**CITY OF ROCKVILLE PLANNING DIVISION
STAFF REPORT & RECOMMENDATION**

January 21, 2009

FINAL RECORD PLAT: PLT2009-00493
Plat of Subdivision, Lot 1
Fallsmead Elem. School

Exhibit "1" – Proposed Final Record Plat

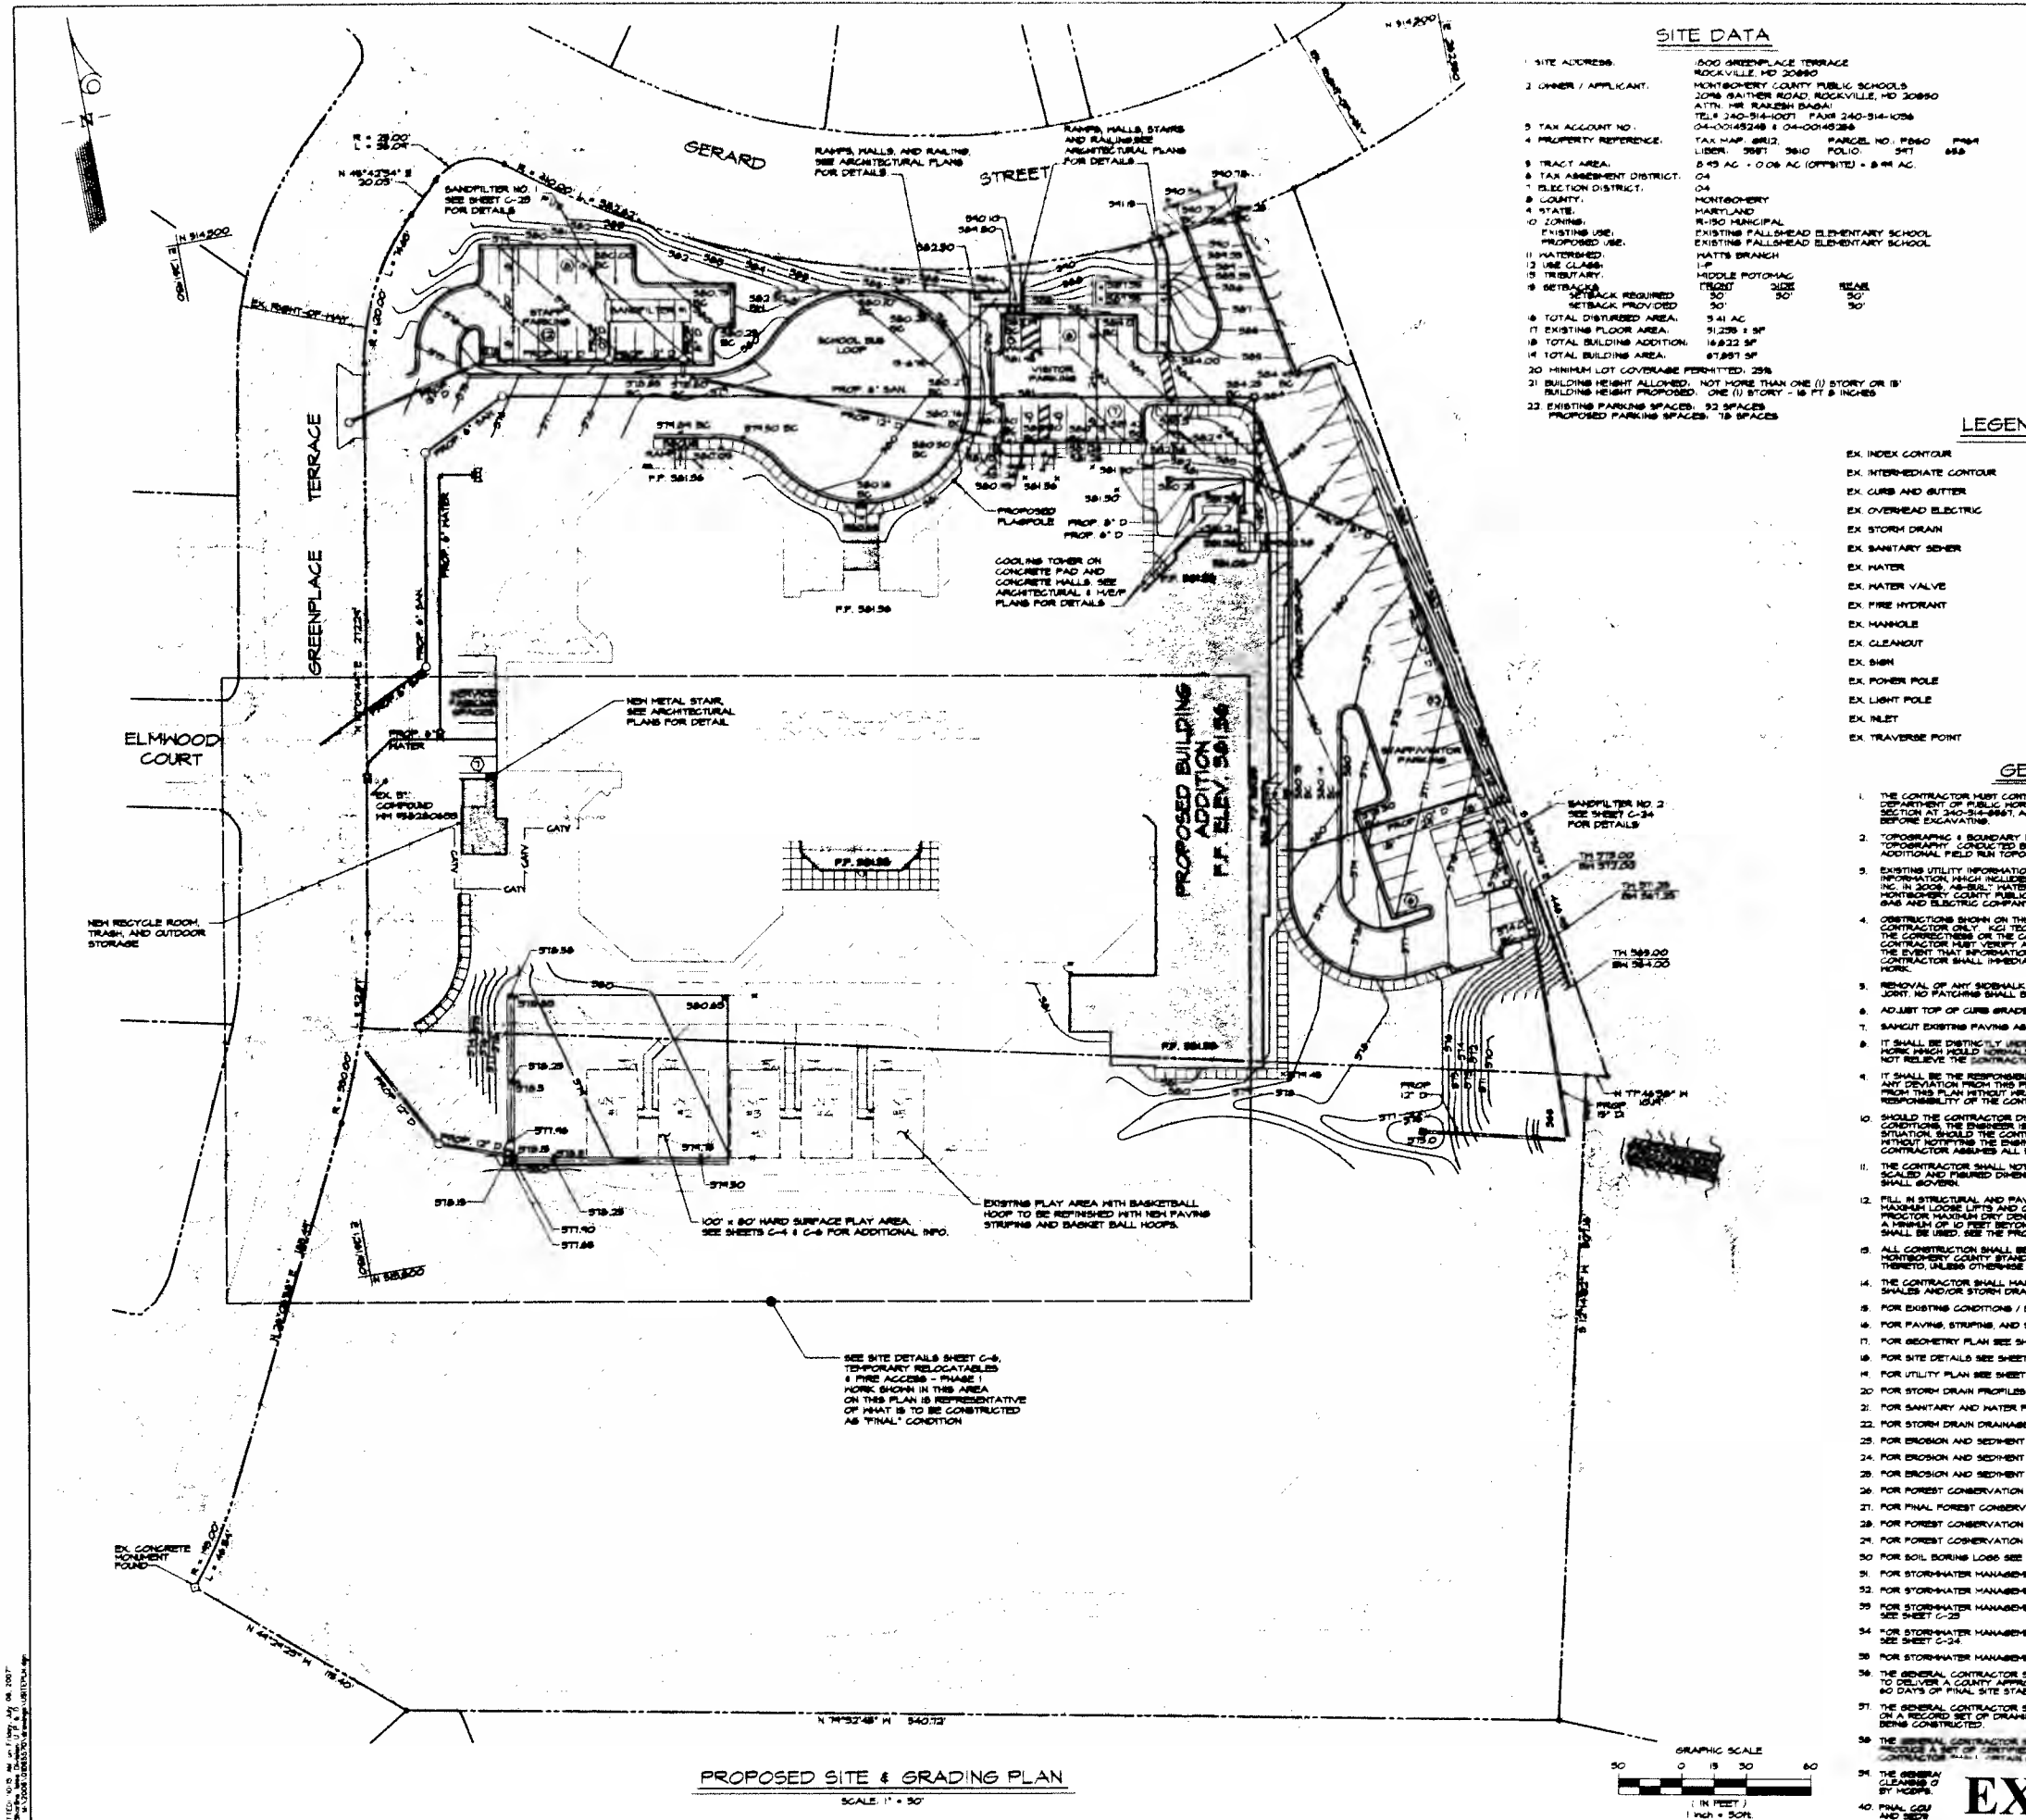
STAFF COMMENTS: The subject final record plat is submitted as required via previously approved Use Permit USE2007-00706. Under the final record plat as submitted, the applicant proposes to consolidate the site's two deeded parcels into a single record lot (See Exhibit 1).

1. All existing and proposed easements must be clearly shown and identified on the plat, i.e., stormwater management, public utilities, public improvements, storm drain and sanitary sewer, and stormwater management access, forest conservation, etc.
2. The final corrected record plat must be submitted in an appropriate electronic format as specified in Section 25-782(c)(d) and (e) of the City of Rockville Zoning Ordinance.

3. The plat must be revised to make modifications/revisions as identified on Planning Commission Exhibit "A", on file in the Planning Division Office.

Note: The area of the Forest Conservation Easement was decreased from the approved Forest Conservation Plan (FCP) due to the Public Utility Easement being added along Greenplace Terrace. Thus, the FCP must be amended to reflect this and forest conservation credit made up by this loss.

Exhibit "2" – Site Plan –USE2007-00706

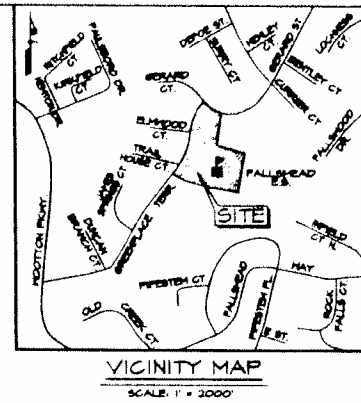
As constructed, the school's new and/or expanded parking facilities and new school bus loop are accessed via Gerard Street or Greenplace Terrace respectively (See Exhibit 2). The proposed bus turnaround that can only be accessed via Greenplace Terrace was designed to maintain physical separation between the bus loop and the new expanded staff/visitor site parking lot to the east. Such physical separation of the site's new staff/visitor parking lot and the new bus loop, are designed to ensure that school bus and service delivery vehicles do not interfere with or pose a safety concern to the on-site traffic flow movement of staff/visitor passenger vehicles.
